Process Change Notice #1511251

PCN Date: 11/25/2015		Effective Date: 3/1/2016	
Title: Si533xx QFN Ship Media Change			
Originator: Murali Chandran		Phone: +1-512-464-9278	Dept: Marketing
Customer Contact: Kathy Haggar		Phone: +1-512-532-5261	Dept: Customer Service
PCN Type:			
<input type="checkbox"/> Datasheet	<input type="checkbox"/> Foundry	<input checked="" type="checkbox"/> Packing	
<input type="checkbox"/> Product Revision	<input type="checkbox"/> Assembly	<input type="checkbox"/> Labeling	
<input type="checkbox"/> Discontinuance	<input type="checkbox"/> Test	<input type="checkbox"/> Other	
Last Order Date: N.A			
PCN Details			
Description of Change:			
Silicon Labs is pleased to announce a change in shipping media from tube to tray for Si533xx QFN packages in bulk shipping media (i.e. orders not in tape and reel). The tray complies with industry standard JEP 95 Sec 4, describing design guidelines for low profile matrix tray, as defined in CO-034D. This change in ship media occurs coincident with the test capacity expansion for the Si533xx QFN products. KYEC Chunan (King Yuan Electronics Company) is added as a qualified test and shipping site for this product family.

a. Sunrise tray drawing - 16-QFN-3X3

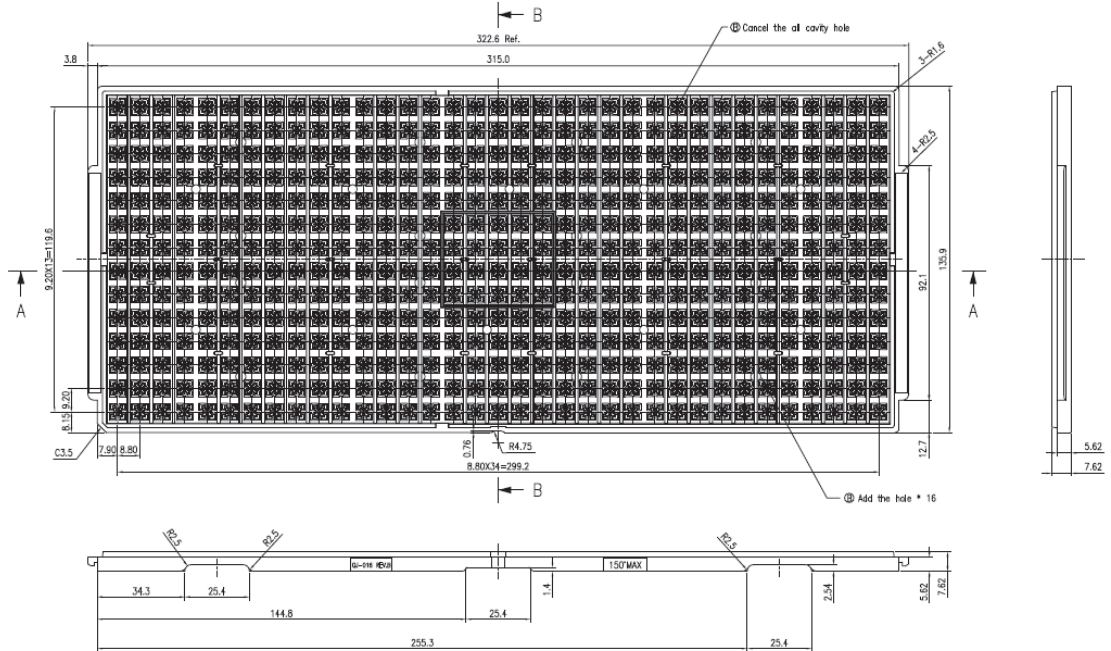
KYEC Chunan is an existing fully qualified test supplier for Silicon Labs Timing product families, certified and registered to ISO 9001, ISO 14001, ISO/TS 16949 and a Sony Green Partner.			
After the effective date of this PCN, Silicon Labs will ship in trays for Si533xx QFN Clock Buffer bulk orders.			
Reason for Change:			
This change is being implemented to support a capacity expansion			
Impact on Form, Fit, Function, Quality, Reliability:			
Only the form of the bulk shipping media will change. There is no impact on Form, Fit, Function, Quality and Reliability of the IC component. The same test equipment including ATE, test load board hardware and test software will be used at KYEC as that currently used at other Silicon Labs test sites. Please refer to Appendix A for drawings of trays that will be used with QFN-3x3, QFN-5x5 and QFN-7x7.
